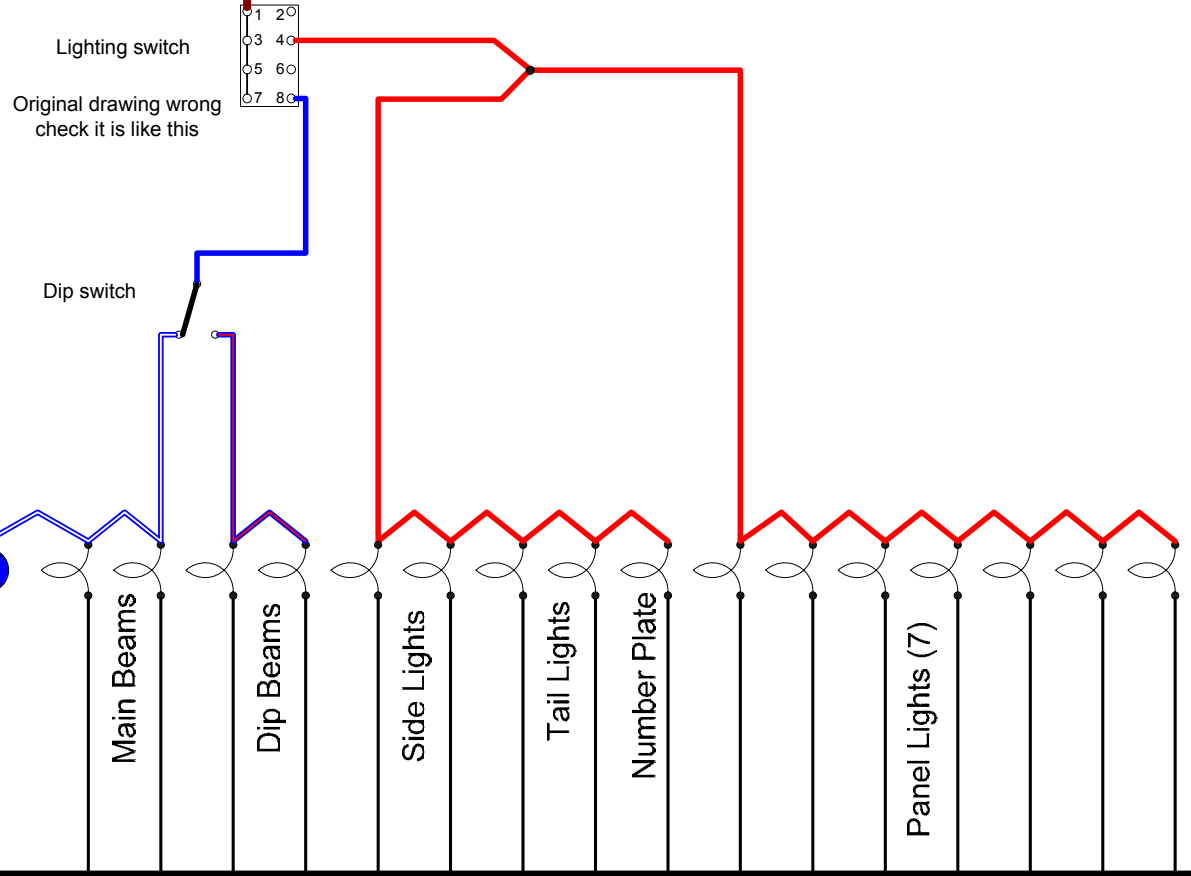
Current loop tacho not shown on original drawing

Original drawing wrong check it is like this

This white connection should be removed and changed to the green dotted one
The fan interferes with the Tacho otherwise.
